Technical Service Information

THM 4T80-E TURBINE SHAFT SPEED SENSOR CHANGES

CHANGE: Beginning in the 1996 model year, on Julian Date 113, all THM 4T80-E transaxles were produced with a new design case casting, manual shaft and turbine shaft speed sensor.

Figure 1

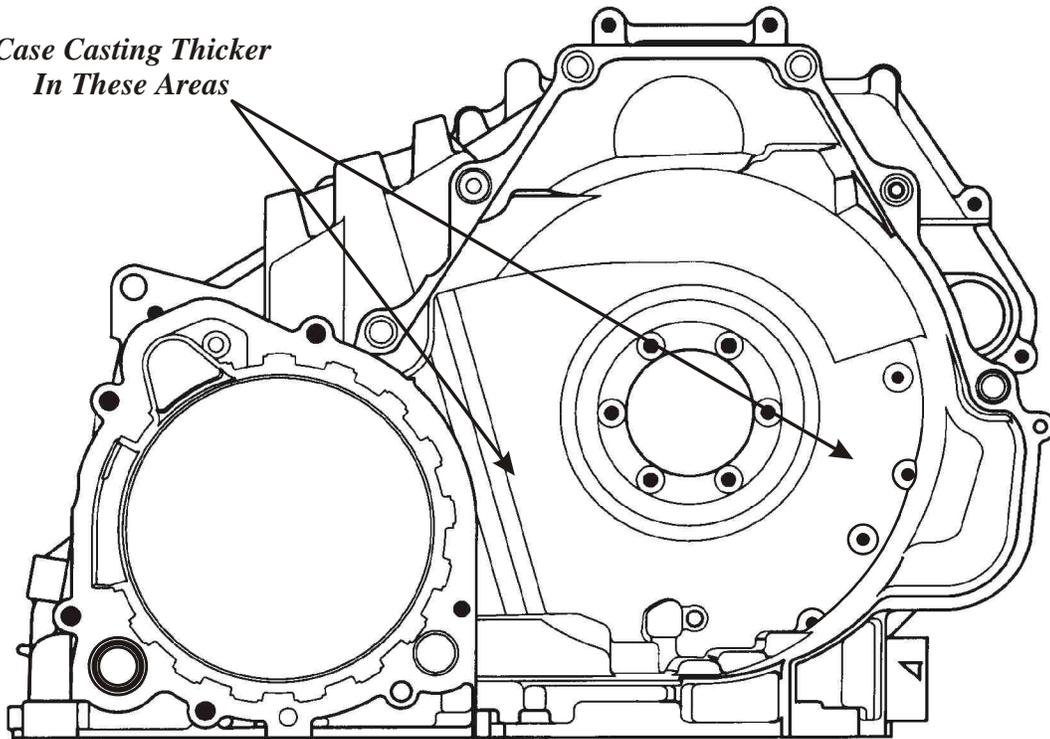
- (1) TRANSAXLE CASE - Thicker casting in the front seal area to help eliminate possible cracks and leakage and revised machining in the manual shaft seal bore area (See Figure 1).
- (2) MANUAL SHAFT - New design manual shaft has groove cut in shaft, to accept the bump on bottom of the turbine speed sensor wiring bracket, to locate and hold the manual shaft in the proper location in case (See Figure 1).
- (3) TURBINE SPEED SENSOR - Now manufactured with the bump on the bottom of turbine speed sensor wiring harness bracket, to position and retain manual shaft. The 1st design parts are shown in Figure 2 and the 2nd design parts are shown in Figure 3.

*Case Casting Thicker
In These Areas*

Figure 2

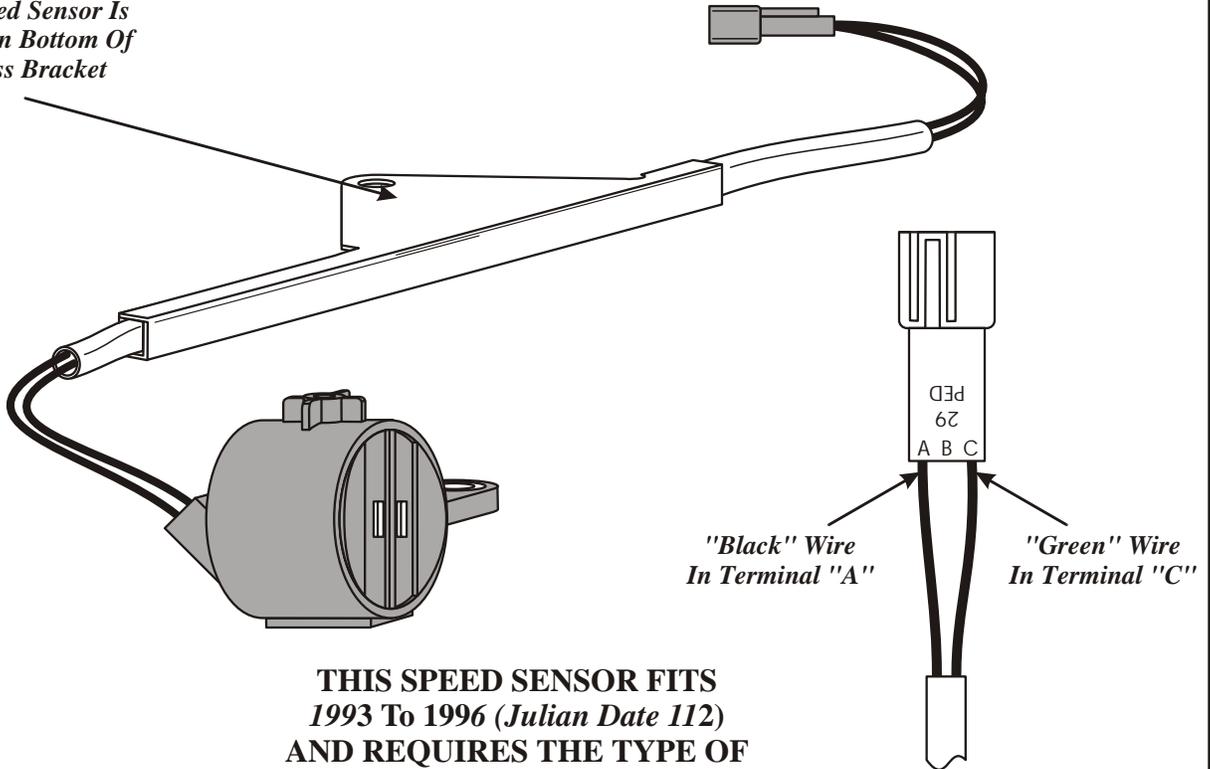
**THM 4T80-E 1ST DESIGN TURBINE SHAFT SPEED SENSOR
OEM PART NUMBER 24209654**

*This Speed Sensor Is
"Flat" On Bottom Of
Harness Bracket*

**THIS SPEED SENSOR FITS
1993 To 1996 (Julian Date 112)
AND REQUIRES THE TYPE OF
MANUAL SHAFT SHOWN BELOW**

If it becomes necessary to replace the turbine speed sensor, ensure that your new sensor has the wires in terminals "A" and "C", as shown here. We have had some reports that the new sensor came with the green wire in terminal "B" and had to be moved to terminal "C". We have also had some reports of the black wire being in terminal "A" and the green wire being in terminal "B" on both sides of the connecting harness. Ensure that your wires match on both sides of connector, regardless of where they are located.

Figure 3

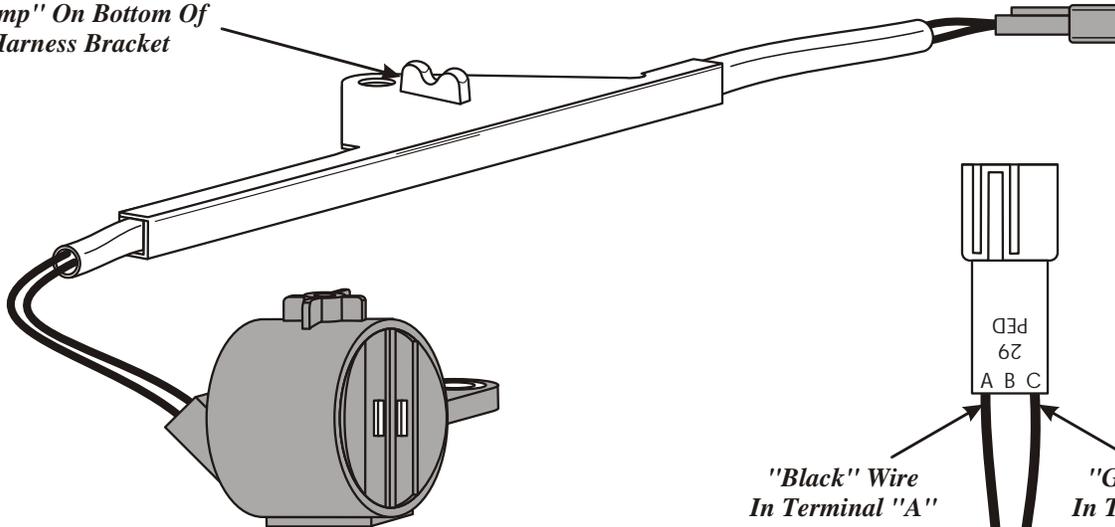
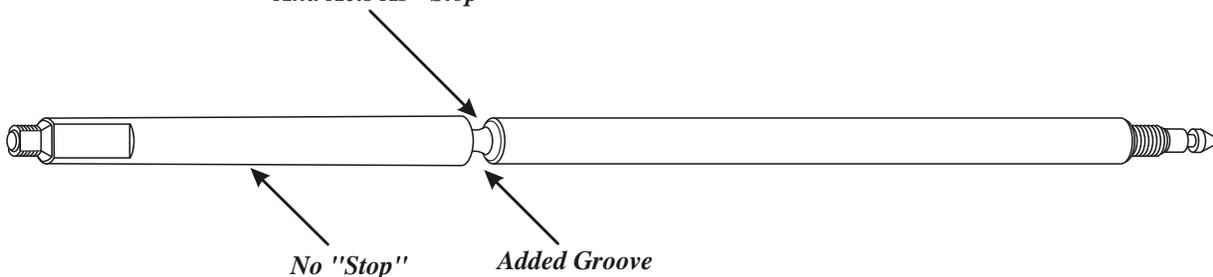
THM 4T80-E 2ND DESIGN TURBINE SHAFT SPEED SENSOR OEM PART NUMBER 24207491

*This Speed Sensor Has
"Bump" On Bottom Of
Harness Bracket*

**THIS SPEED SENSOR FITS
1996 (Julian Date 113) TO CURRENT
AND IS "MANDATORY" FOR
THESE MODELS AS TRANSAXLE
IS EQUIPPED WITH THE MANUAL
SHAFT SHOWN BELOW**

*"Bump" On Bottom Of Harness Bracket
Fits Into Groove In Manual Shaft And
Positions Manual Shaft In Case
And Acts As "Stop"*

If it becomes necessary to replace the turbine speed sensor, ensure that your new sensor has the wires in terminals "A" and "C", as shown here. We have had some reports that the new sensor came with the green wire in terminal "B" and had to be moved to terminal "C". We have also had some reports of the black wire being in terminal "A" and the green wire being in terminal "B" on both sides of the connecting harness. Ensure that your wires match on both sides of connector, regardless of where they are located.
